SPECIAL CAP MEETING – 4 December 2024

ITEM 8.1

DEVELOPMENT NO.:	22007004
APPLICANT:	Luxury Lodge Group
NATURE OF DEVELOPMENT:	Tourist accommodation comprising 20 units with ancillary lodge and shop (personal services establishment in the form of a day spa), water tanks, access road and associated earthworks
ZONING INFORMATION:	<p>Zones:</p> <ul style="list-style-type: none"> • Productive Rural Landscape <p>Overlays:</p> <ul style="list-style-type: none"> • Environment and Food Production Area • Hazards (Bushfire - Medium Risk) • Heritage Adjacency • Hazards (Flooding - Evidence Required) • Limited Land Division • Mount Lofty Ranges Water Supply Catchment (Area 2) • Native Vegetation • Prescribed Water Resources Area • Water Resources
LODGEMENT DATE:	9 March 2022
RELEVANT AUTHORITY:	Council Assessment Panel
PLANNING & DESIGN CODE VERSION:	2022.4 - 3 March 2022
CATEGORY OF DEVELOPMENT:	Code Assessed - Performance Assessed
NOTIFICATION:	Yes 09 February to 01 March 2023

LODGE
1 : 150

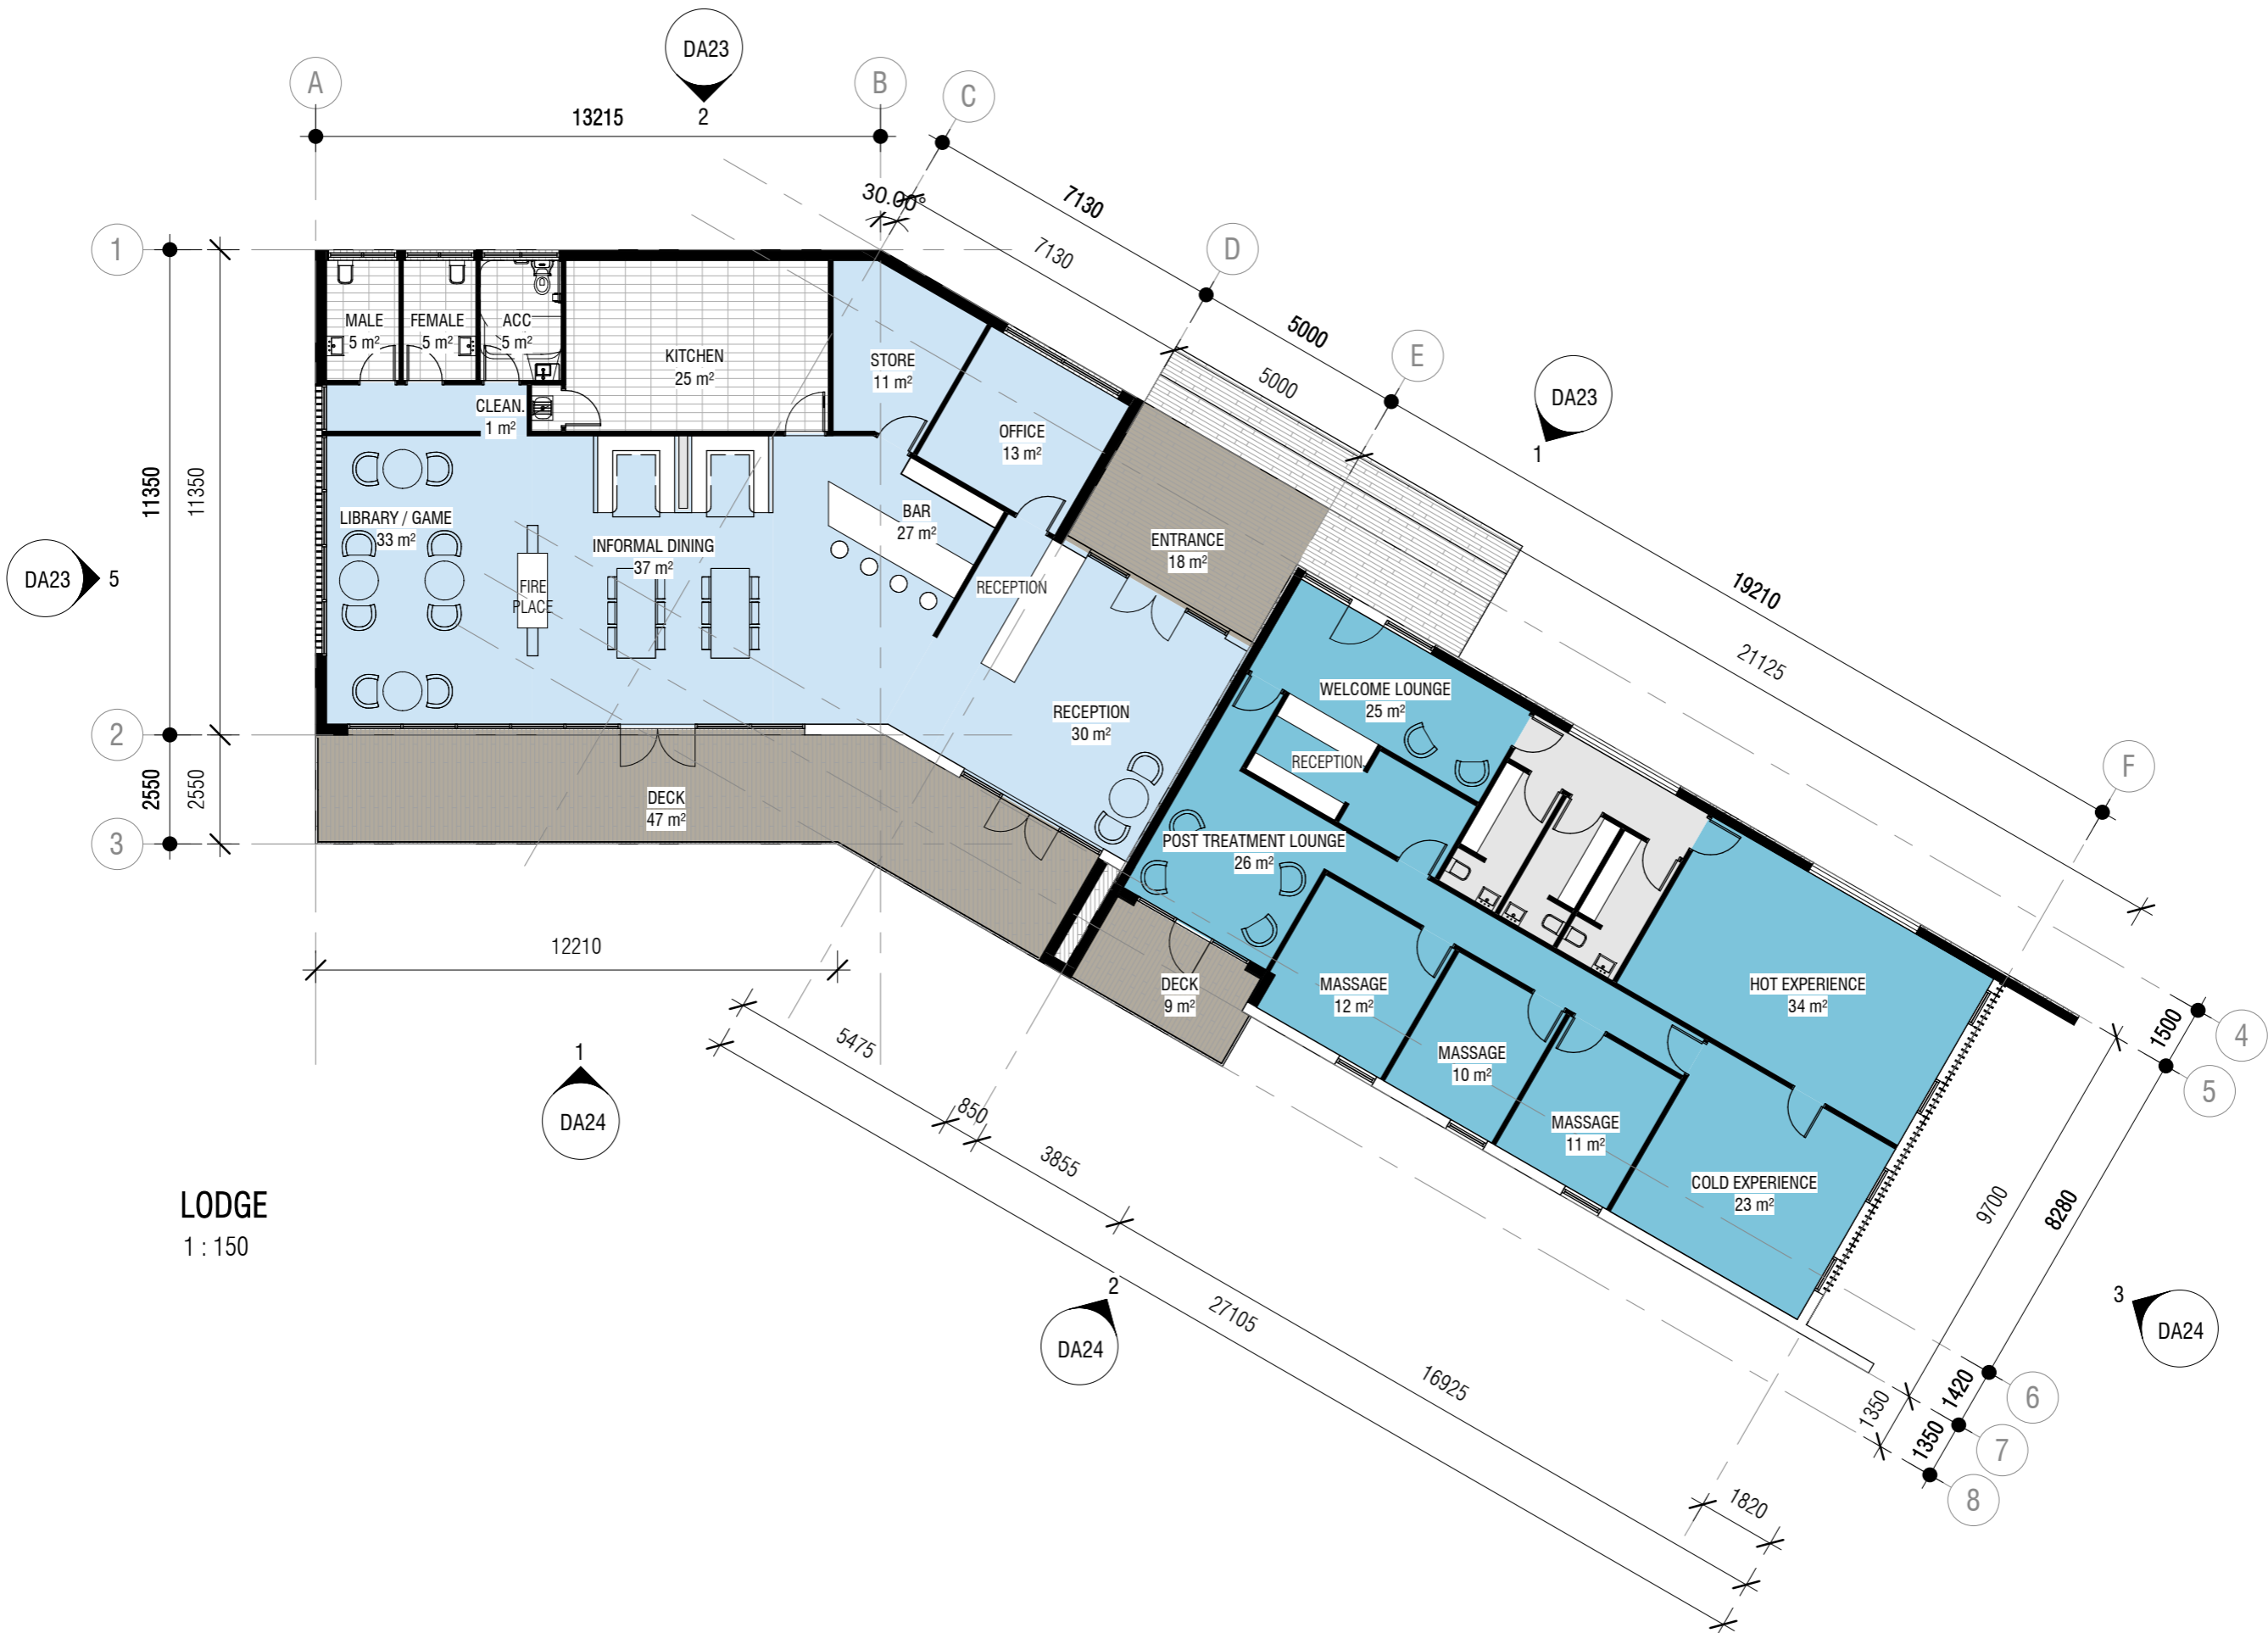
- While the height of the accommodation units does not appear to exceed 7 metres (noting that the proposal plans do not accurately show the height of buildings above natural ground level), the Day Spa building is approximately 9 metres above natural ground level due to the slope of the land and is of significant size, and in an elevated position on the site.

Figure 8: Proposed Amendments to Accommodate CFS Truck and Refuse Truck Turning Path

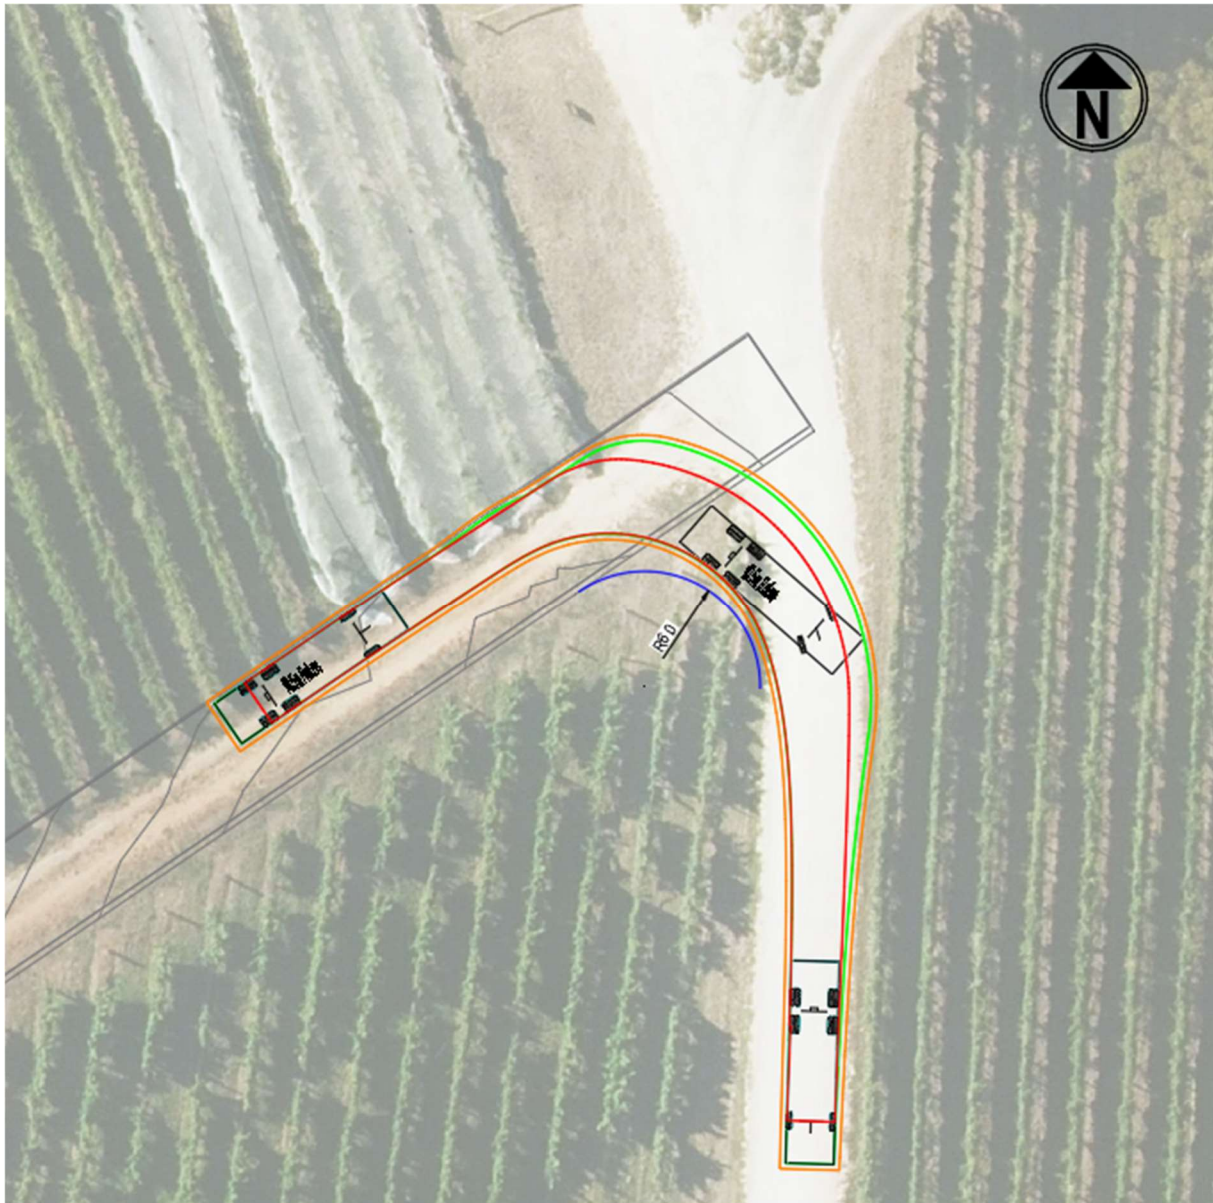
the intersection of the driveways has not been designed to accommodate the turning movements of a refuse vehicle or a fire appliance, as illustrated in Figure 2.

Plans are proposed to be amended to accommodate CFS truck and refuse truck requirements at this internal intersection as shown in Figure 8.
